**UPGRADE
BULLETIN:
190827REV**

**PRODUCT(S)
AFFECTED:**
2020 Fleetwood Flair
2020 Holiday
Rambler Admiral

**MODEL(S)
AFFECTED:**
34 J

SUBJECT:
Correction of 12-
Volt Patio Awning
Circuitry and
Wiring

Figure 2

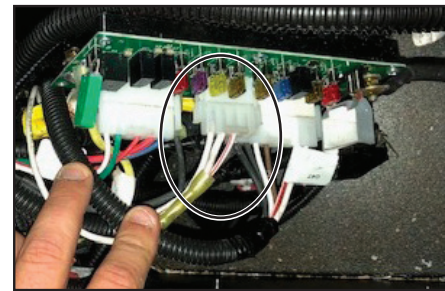
6. With the step cover removed, locate the 4-pin connector on the fuse panel, shown in Figure 2, and remove it from the panel.

7. On this connector, locate the 003AA 12 gauge ignition circuit (white wire) in Position 3 of the four-pin connector.

Figure 3

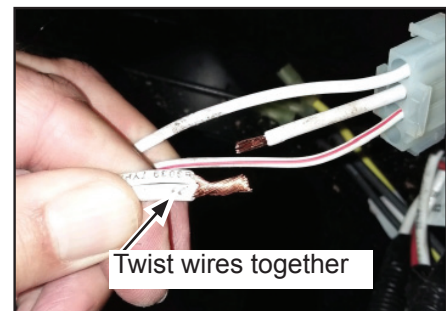
Cut the circuit 2" from the connector and strip 5/8" from the ends of both the 12 gauge circuit and the new 16 gauge jumper wire (provided in the parts kit); twist the copper strands from the wires together as shown in Figure 3.

Figure 4

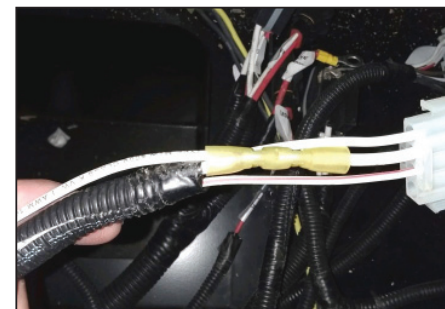
8. Apply a new yellow butt connector to the twisted wires. Take the single wire end of 003AA 12 gauge white wire going to the connector, strip 3/8" from its end, and connect it to the opposite end of the yellow butt splice as shown in Figure 4, making a 3-wire splice. Wrap the connection with two layers of electrical tape after crimping; reconnect this to the fuse panel from where it was removed earlier.

Figure 5

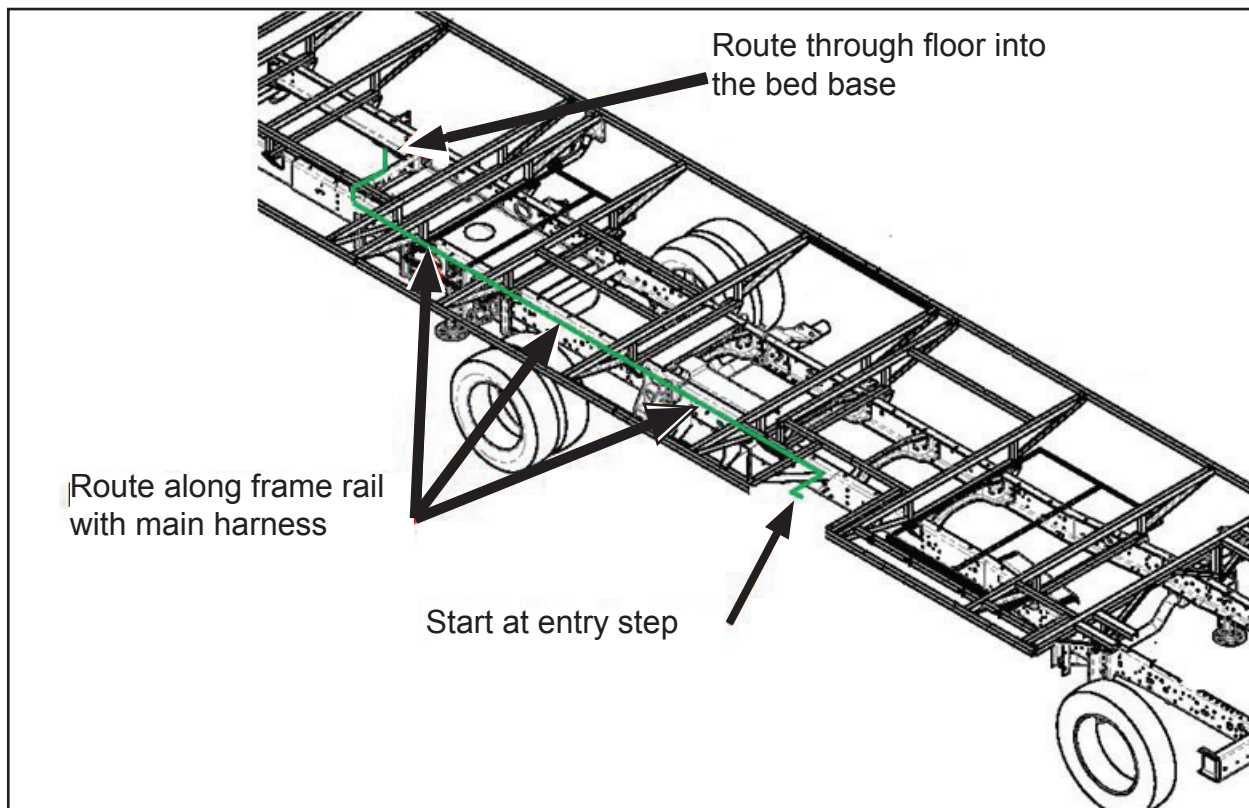
9. Route the remaining length of the new 16 gauge loomed wire out the side of the step well box, following along with the rest of the under-floor harness rearward down the chassis toward the bedroom area. Be sure to route the wire through the existing harness P-clamps. Additionally, install wire ties every 12" to secure the 16 gauge jumper wire to the rest of the harnesses. See Figure 5.

Figure 9

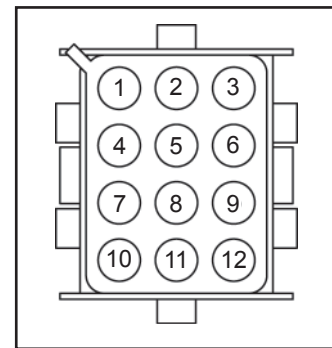
13. Once the correct connection has been found, locate the 16 gauge pink wire labeled 003BB (printed on the wire coating) in position 10 of the 12-pin connector. See the diagram in Figure 9.

Figure 11
(Example of possible miswired connection)

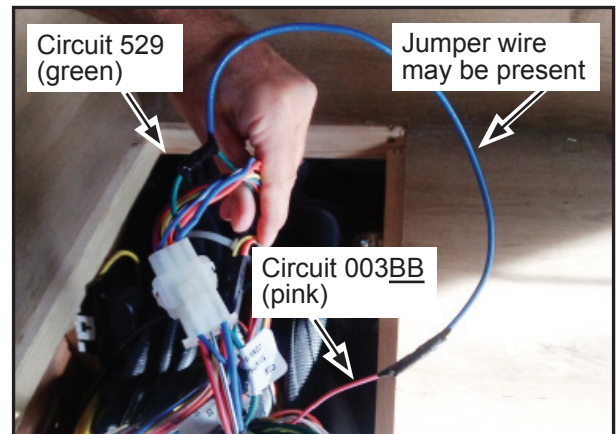
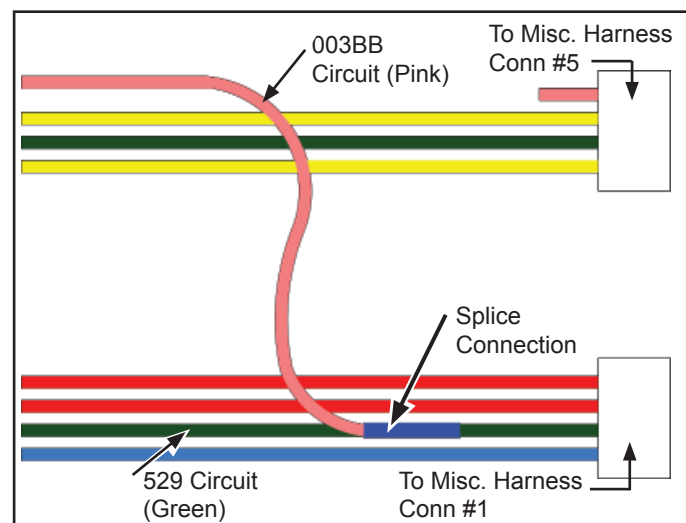
- a) The first scenario would be that the 003BB circuit (pink wire) has been cut and spliced into circuit 529 (green wire). Circuit 529 will be located in an adjacent harness connection labeled as "To Misc Harness Conn #1". Refer to the Figure 10 and the schematic in Figure 11 for this possible condition.

NOTE: A jumper wire may be present, as shown in Figure 10.

14. Based on the scenario found, circuit 003BB (pink wire) will either need to be disconnected from circuit 529 (green wire) or cut at the pinned connector.
 - a) If you disconnect the pink wire from a splice at circuit 529 (green wire), be sure that any exposed copper wiring is appropriately wrapped and covered with electrical tape to prevent arcing.
 - b) If you cut circuit 003BB (pink wire) off of the pinned connector, it can be left uncapped as there is no power feeding this circuit.

Figure 12

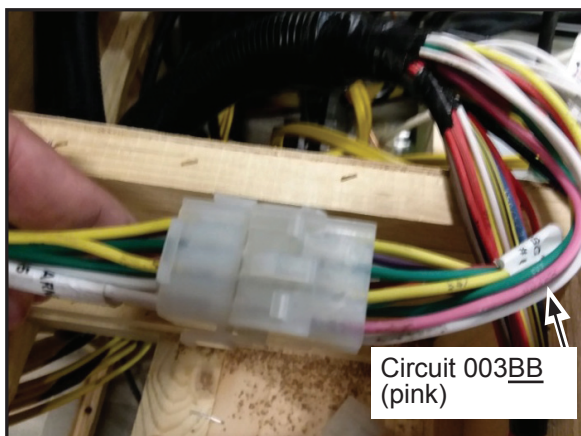
- b) The second scenario would be that the 003BB circuit (pink wire) is still intact and pinned into the original connection labeled "To Misc Harness Conn #5". See Figure 12.

Figure 13

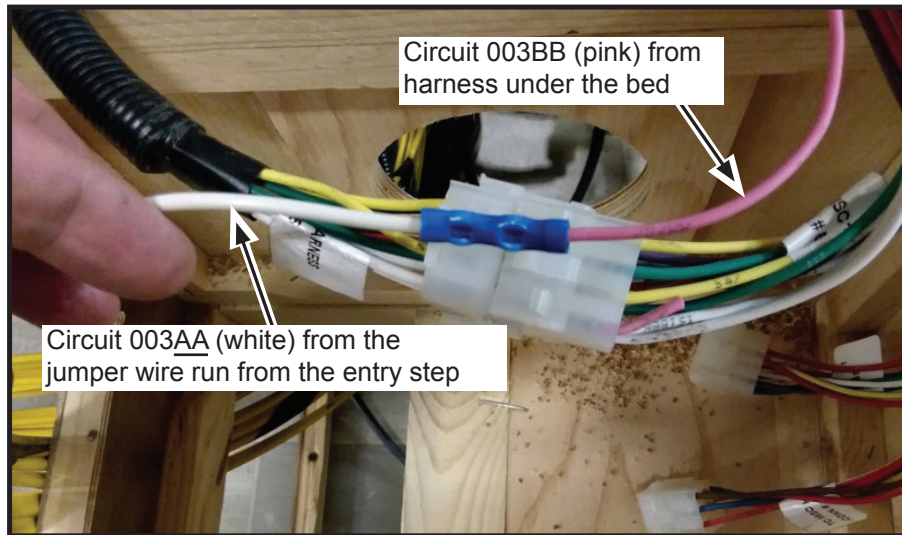
15. Strip 3/8" from the free end of circuit 003BB (pink) that was disconnected in Step 14. Also strip 3/8" from the free end of the white 16 gauge jumper wire (Circuit 003AA) that has been routed from the entry step. Crimp the wires together with the provided blue butt connector. Wrap the connection with 3 half-lapped layers of electrical tape after crimping. Refer to Figure 13.
